EO 55-45-6A

5 Jun 69

LIST OF FIELD MODIFICATIONS
SAFETY HARNESS - GENERAL

Figure 1 (Issue 1)

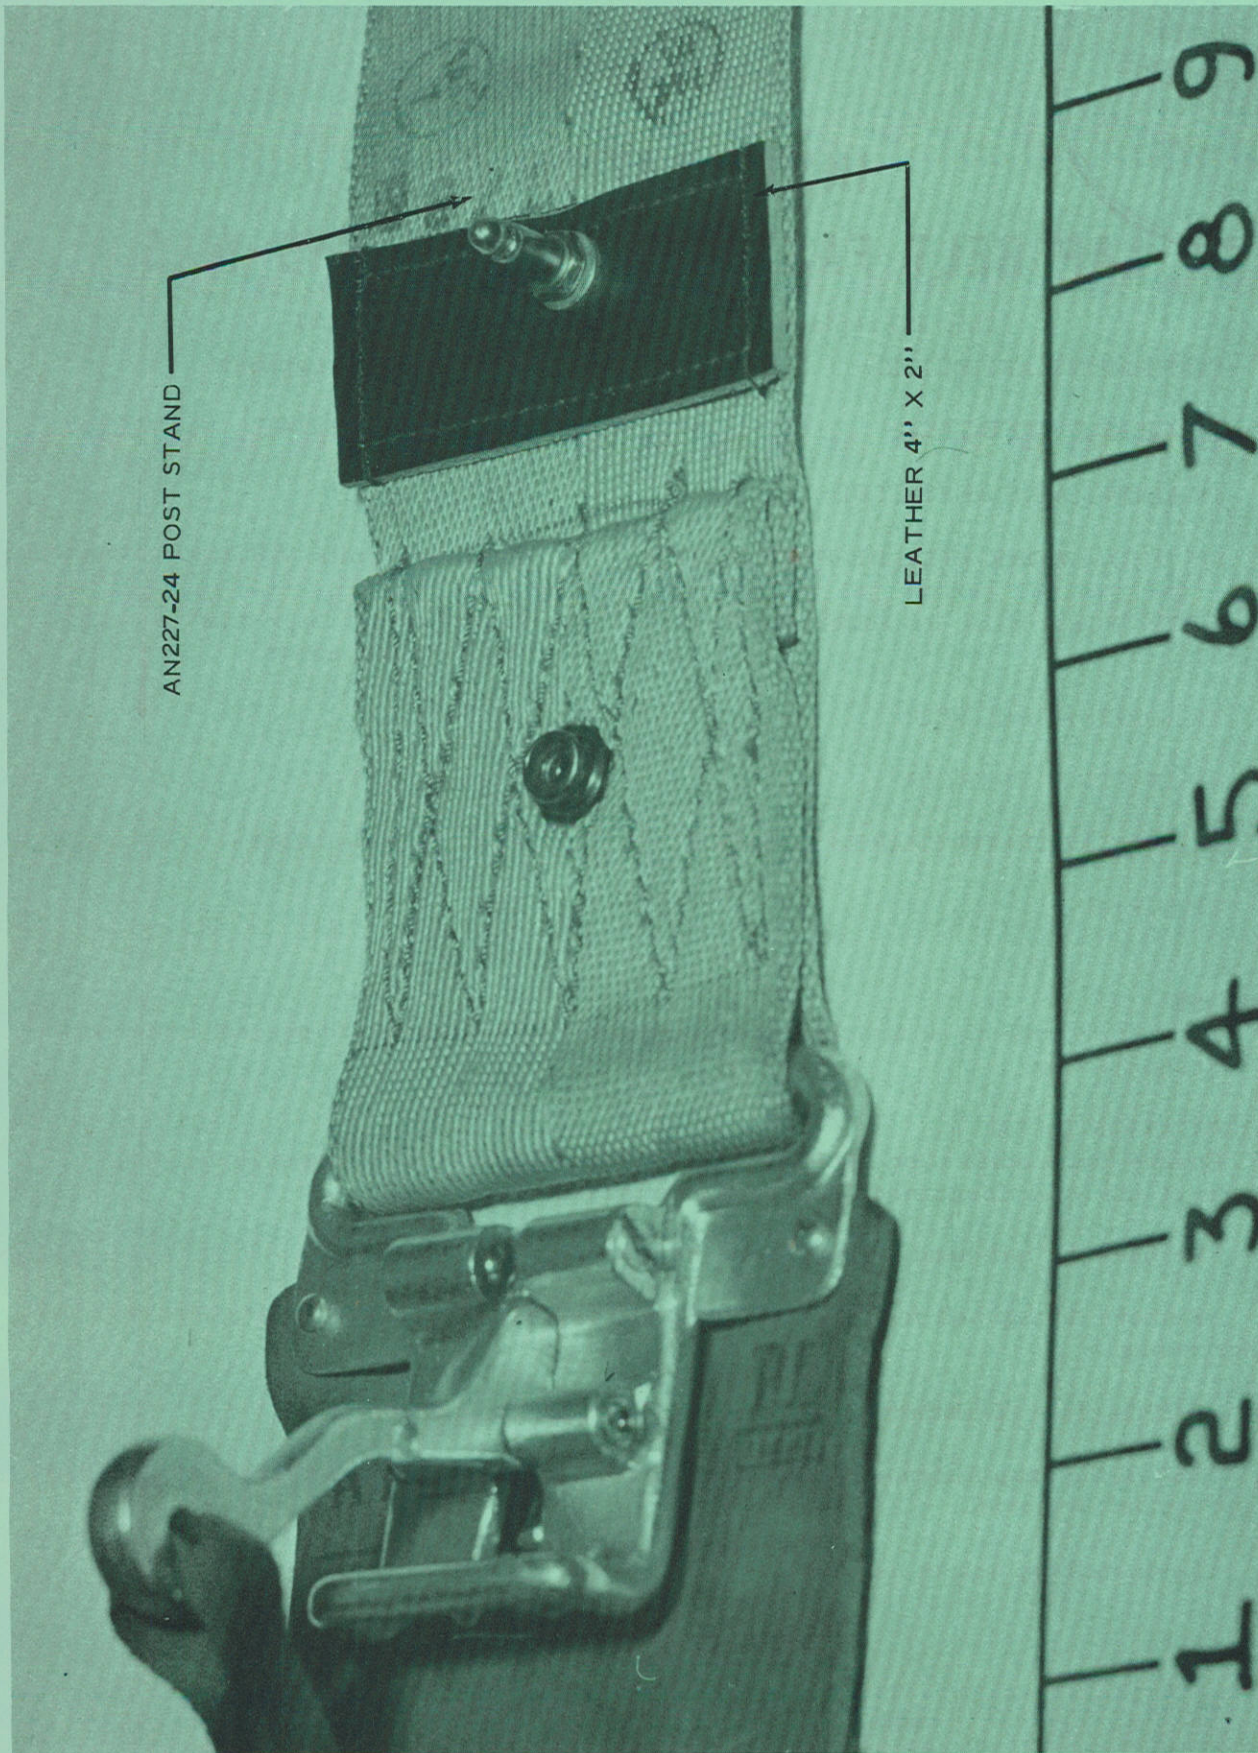
- (a) Remove the left-hand lap belt from the ejection seat.
- (b) Remove the lap belt identification label and reposition so as not to interfere with the leather facing.
- (c) Affix a piece of leather 4" long by 2" wide as shown in Figure 1.
- (d) Install the snap fastener as shown in Figure 1 so that the post penetrates the leather and the lap belt material.
- (e) Re-install lap belt to the seat.

Figure 1

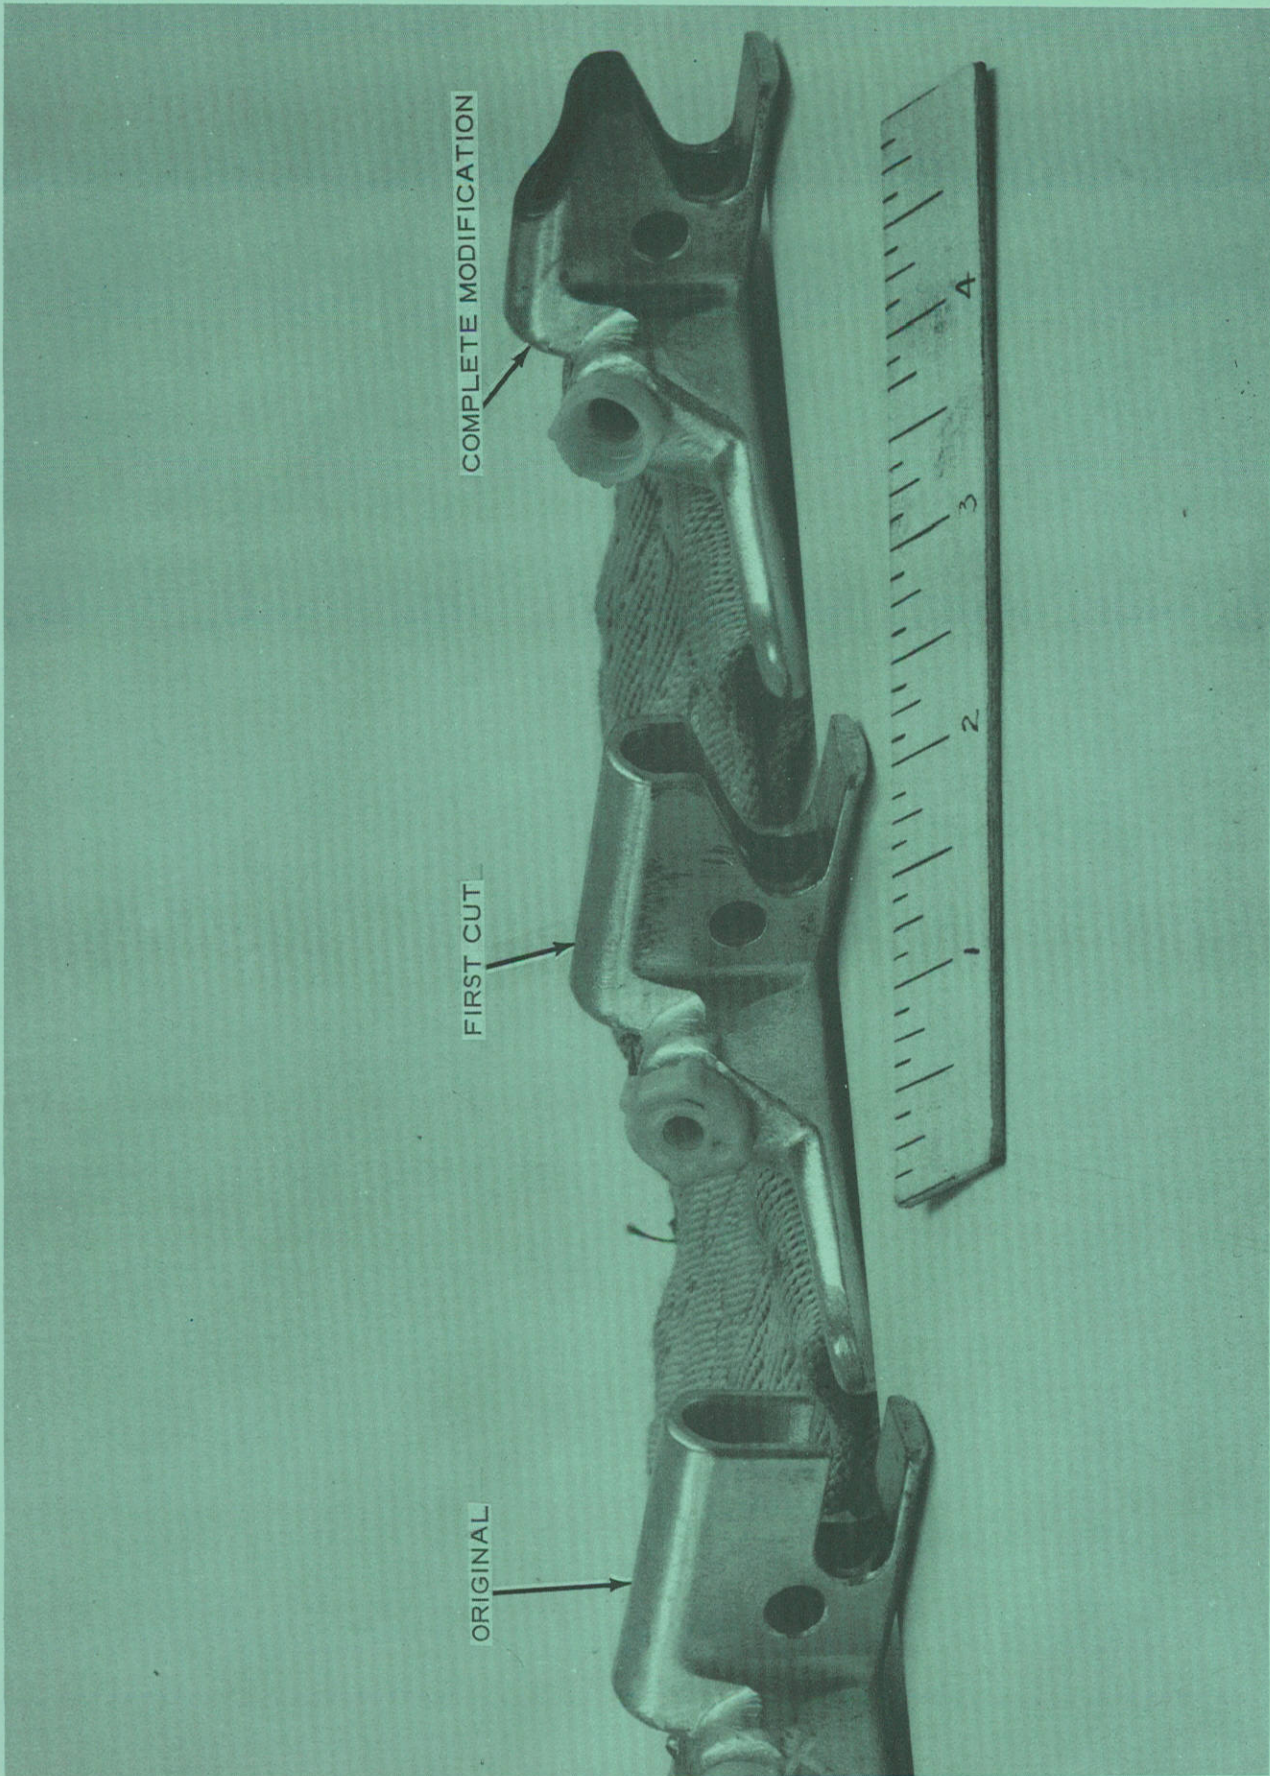
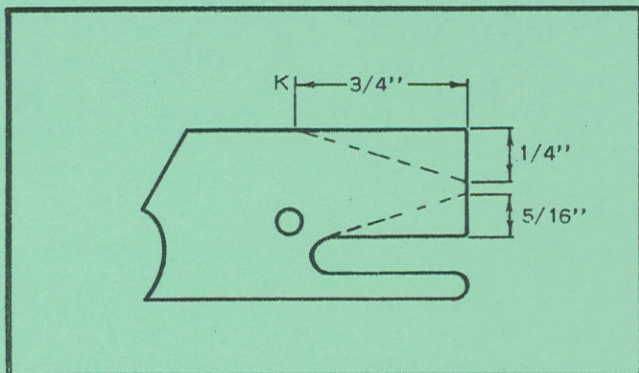
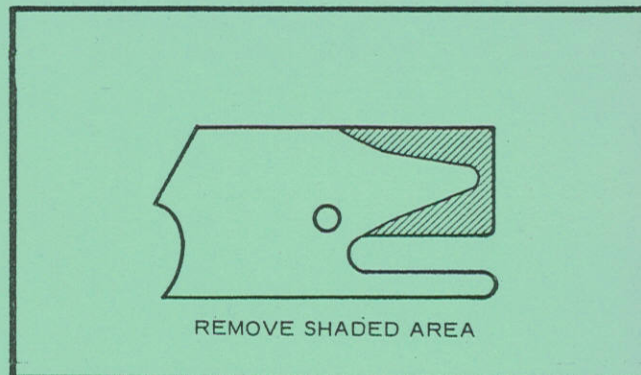
1 To provide a more positive separation between the swivel link and latch when automatically released. This modification enlarges the housing mouth and removes half of the housing crown to allow the latch greater travel.

- (a) Remove the circlip from the latch pin and remove pin and latch from housing.
- (b) Scribe a line from the back of the housing mouth to a point $5/16$ " above the front upper lip of housing mouth, see Figure 2.
- (c) Scribe a line from a point $3/4$ " back on the top of housing to the front of the housing at a point $1/4$ " down from the top, see Figure 2.
- (d) Cut along these lines, taking care that the hacksaw is held at the proper angle to ensure both sides are cut identically.
- (e) Round off the two points thus formed and remove all rough edges. Polish with abrasive cloth, see Figures 1 and 3.
- (f) Remove all filings.
- (g) Re-install the latch, pin and circlip.

Figure 1 C2 Seat Lap-Belt Extension Tab

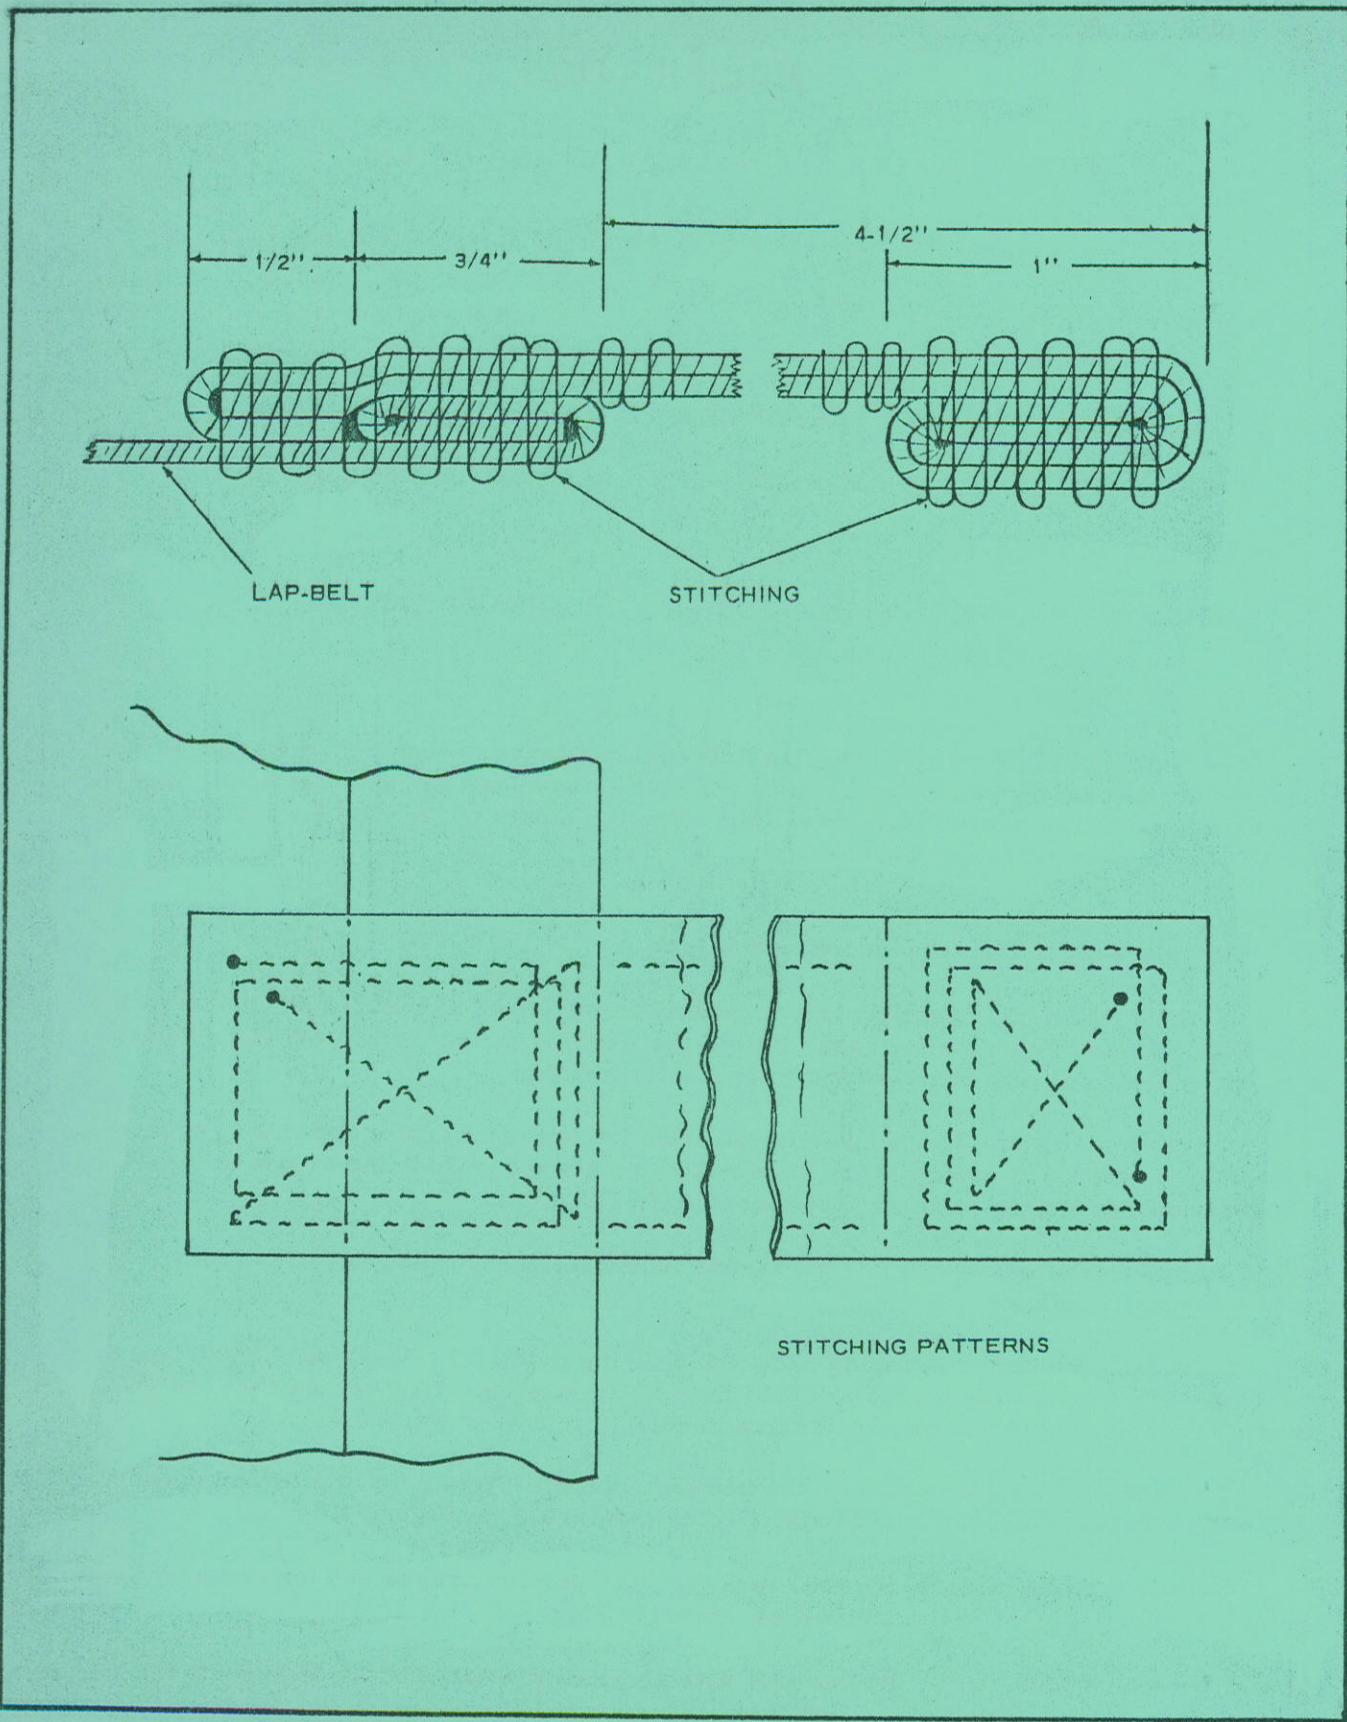
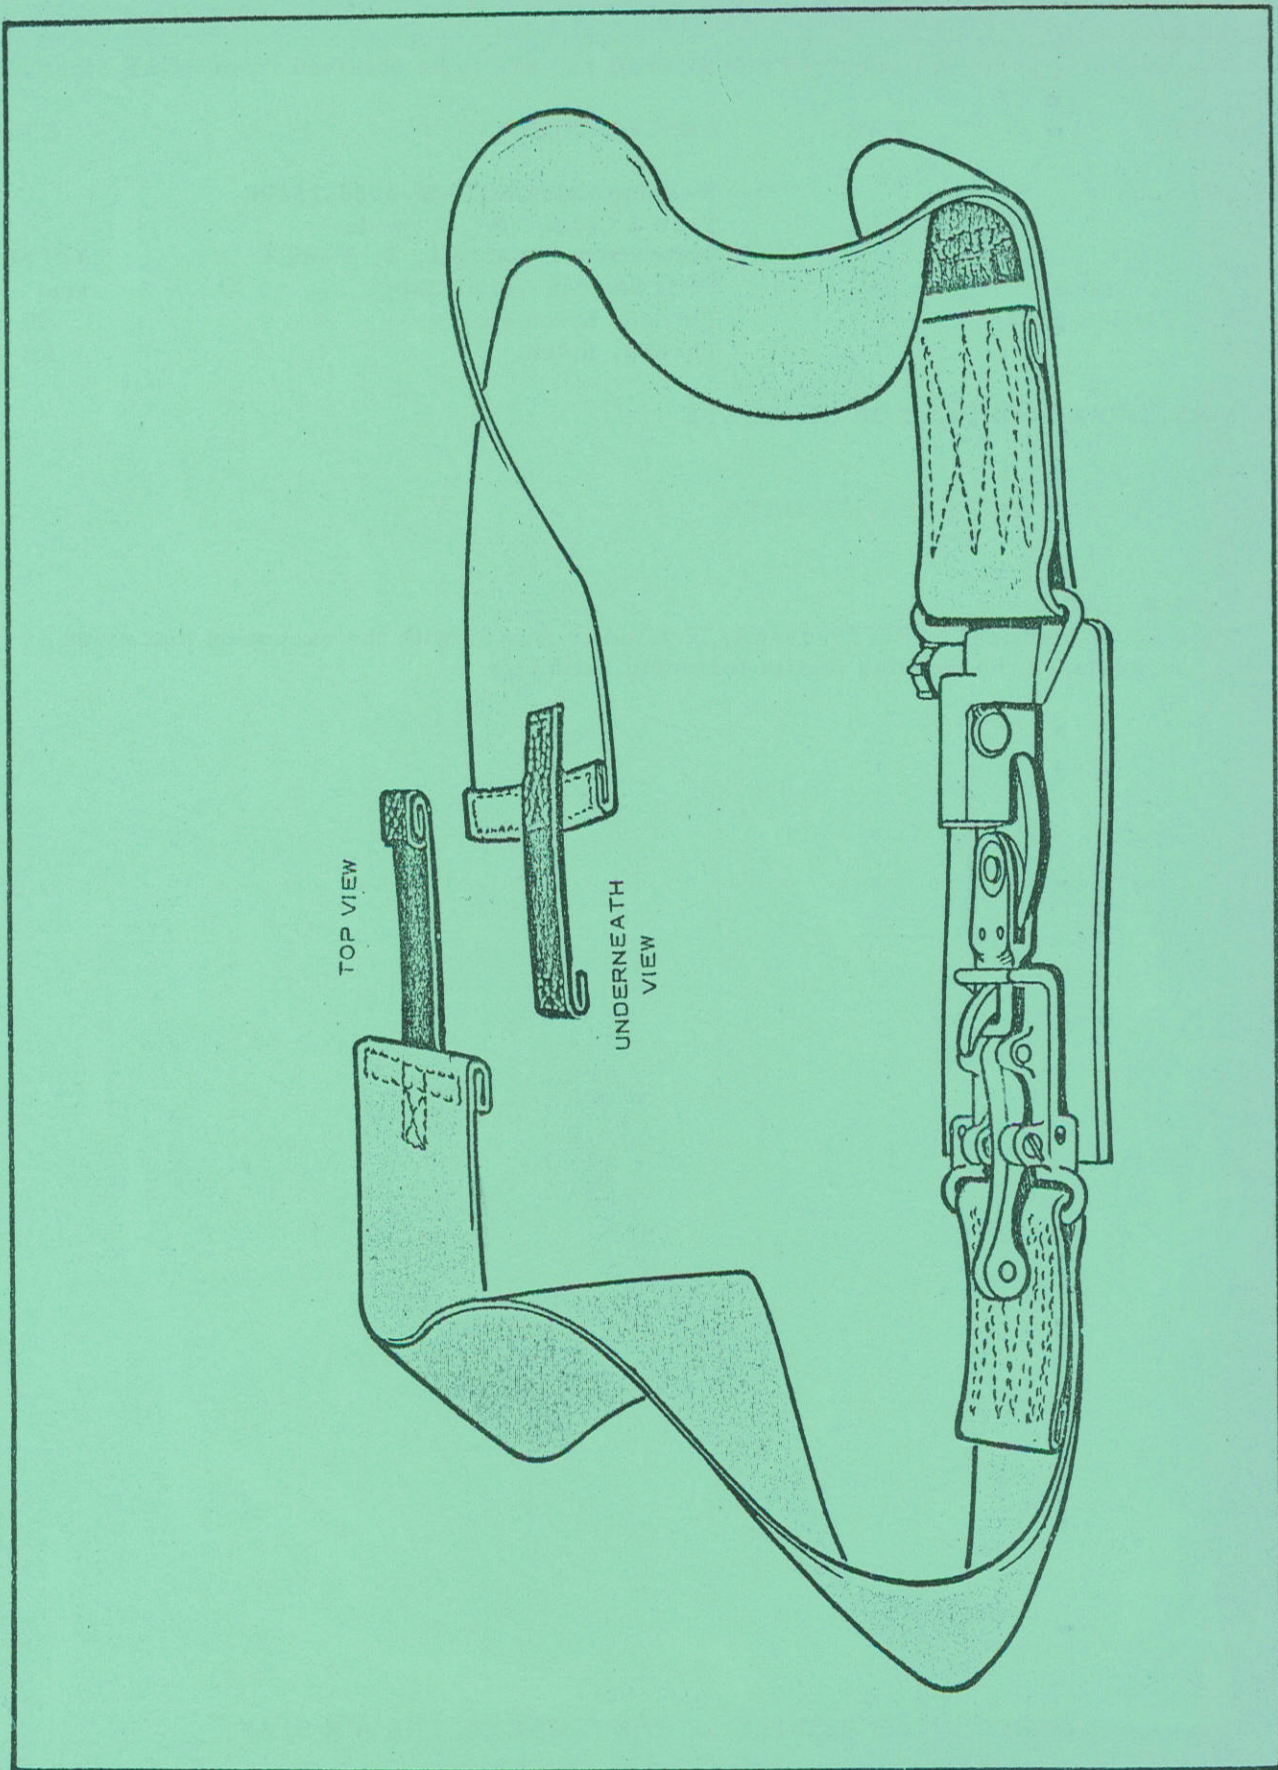
(1) Cut a 16" length of webbing 32B/NIC webbing nylon MIL-W-4088, TS600, type 2, condition "R", 1" wide olive drab and fold in two with one side 1/2" longer than the other. Using the folded end tuck under in a double 1" fold, see Figure 1.

(2) Oversew the folded end with the pattern shown in Figure 1 using thread nylon Ref. 32B/8310-21-806-5032 four to six stitches per inch, see Figure 1.

(3) Take the free ends of the tab, tuck the 1/2" portion around and under the shorter end of the webbing. Sew to the lap belt as shown in Figure 1.

(4) Sew tabs along both sides so that both parts of the tab webbing will be attached to each other, see Figure 2.
